Re: Saratoga Property Owner, LLC – 35 Saratoga Boulevard Proposed Industrial Building
Parcel ID#: 021.0-0013-1600.0
IBI Project No. **122047**

IBI Placemaking has reviewed the third submittal for 35 Saratoga Boulevard Level 2 Unified Permit Application and 35 SARATOGA BOULEVARD - SITE DEVELOPMENT PLANS.

See screen shot below from submitted sheet L.1 for the zone highlighted in green:

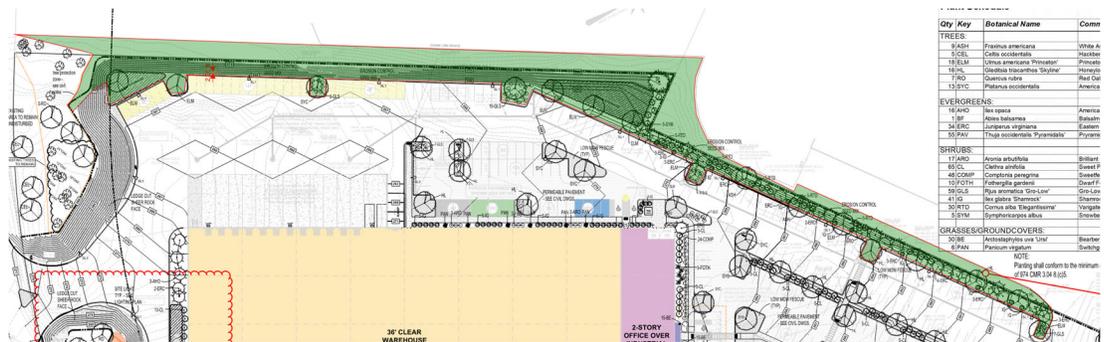
Most of the west edge of the site is graded at slopes of 2:1. An erosion control mix is called for in these areas. A 2:1 slope is too steep to maintain with the annual mowing required for establishment of these proposed seed mixes.

Given the steepness of the slopes, IBI Group recommends DEC request a Landscape Maintenance Memo to ensure establishment of the proposed plantings can be achieved for slope stabilization that does not require mowing.

The establishment plan should consider the use of an appropriate seed mix, the planting of nut caches, seedlings, saplings, and live stakes. Ensure that the plant palette includes woodland tree and shrub species appropriate to early and future successional growth for the naturally wooded slopes at Devens such as the shrub species of blueberry, rhododendron, winterberry, bayberry, shrub dogwoods, cranberry bush, spicebush, and native viburnums.

The revised documentation should include the use of an erosion control seed

mixture, biodegradable jute mat fabric, 1” whip native trees, and shrubs of the species indicated above. The seed mixture should utilize a variety of grasses that will form a strong fibrous root system as indicated in 3.04 (8) (f) 3 to hold soil in place.

We understand the Applicant has agreed to provide an additional 30 trees within Devens as mitigation for the requested screening waivers. As discussed with DEC, these trees may better serve the project if they are to be integrated into this revised screening approach that includes the adjacent landowners.

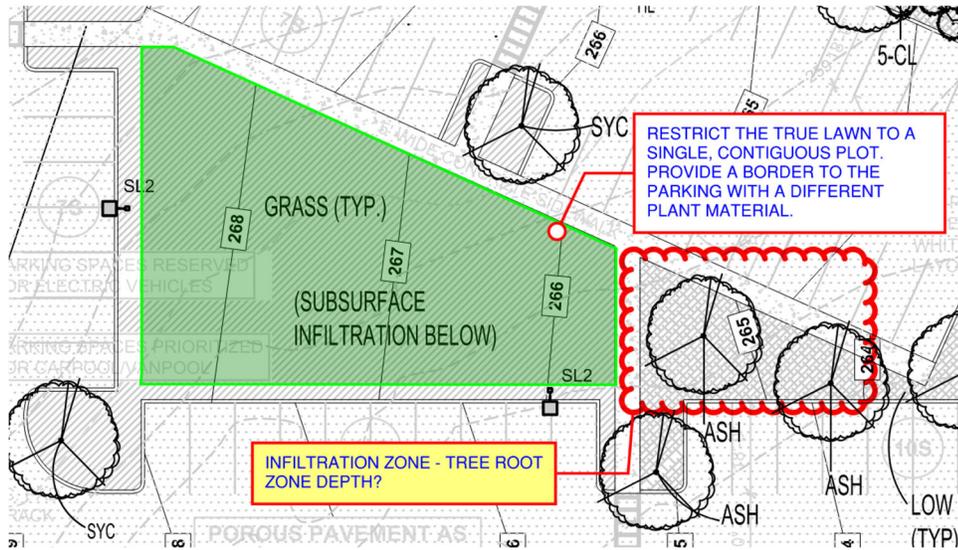
6. SHEET L.1 – LANDSCAPE PLAN – Consider combining the entries off of Barnum Road to reduce the amount of blasting required through the highest point on the site, with a mature forest canopy within the OPEN SPACE AND RECREATION ZONING DISTRICT and eliminate the redundant fire access drive.

We have combined the entries as requested

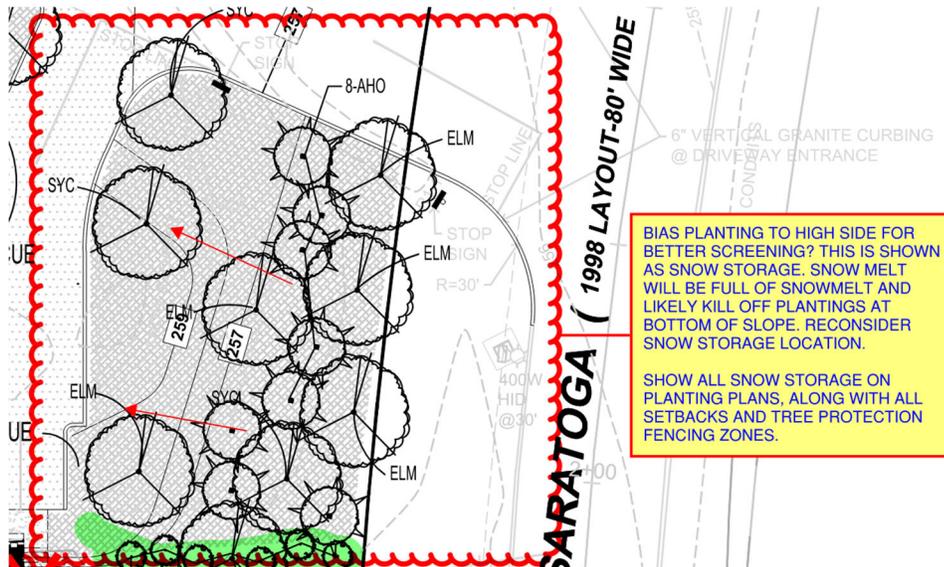
- 7. SHEET L.1 – LANDSCAPE PLAN – Consider reducing the amount of true lawn:

This has been revised.

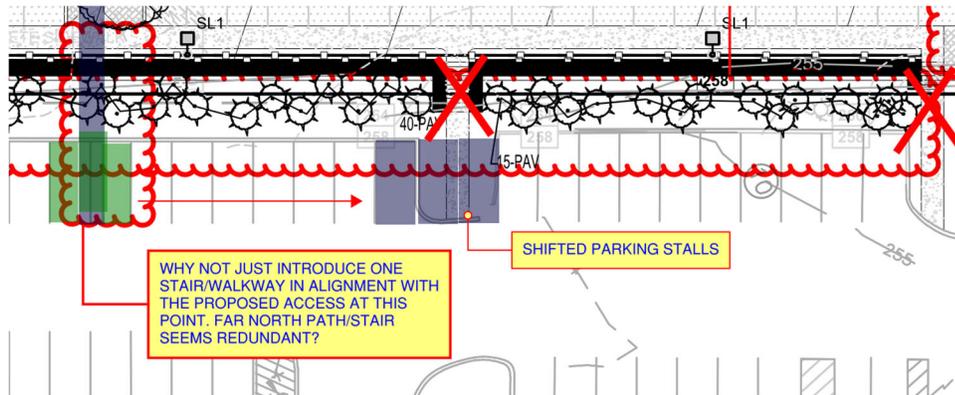
- 8. SHEET L.1 – LANDSCAPE PLAN – Consider revising the screen planting at the entry off of Saratoga Boulevard:

Snow storage is now indicated, but planting has not been revised.

This has been revised.

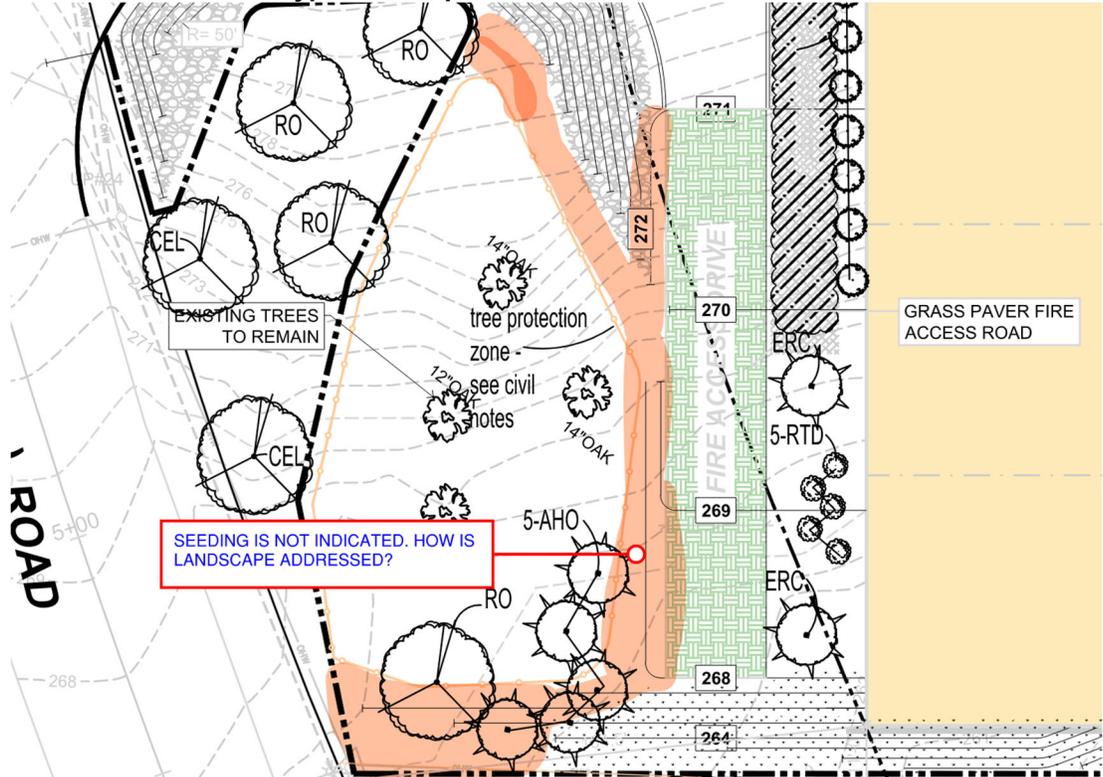
9. **This comment was addressing the planted areas between the cut slopes and the fire lane. Some are now exposed rock, but in the spaces between the protection fence zones and the hardscape, they require some type of landscape treatment. As per 3.04 (8) (c) 11 disturbed areas intended for natural re-growth to be, at a minimum, graded, loamed, and seeded.**

Ensure all disturbed areas within the limit of work are addressed. See screenshot below for typical example:

Plantings have been added between the fire access lane and the building.
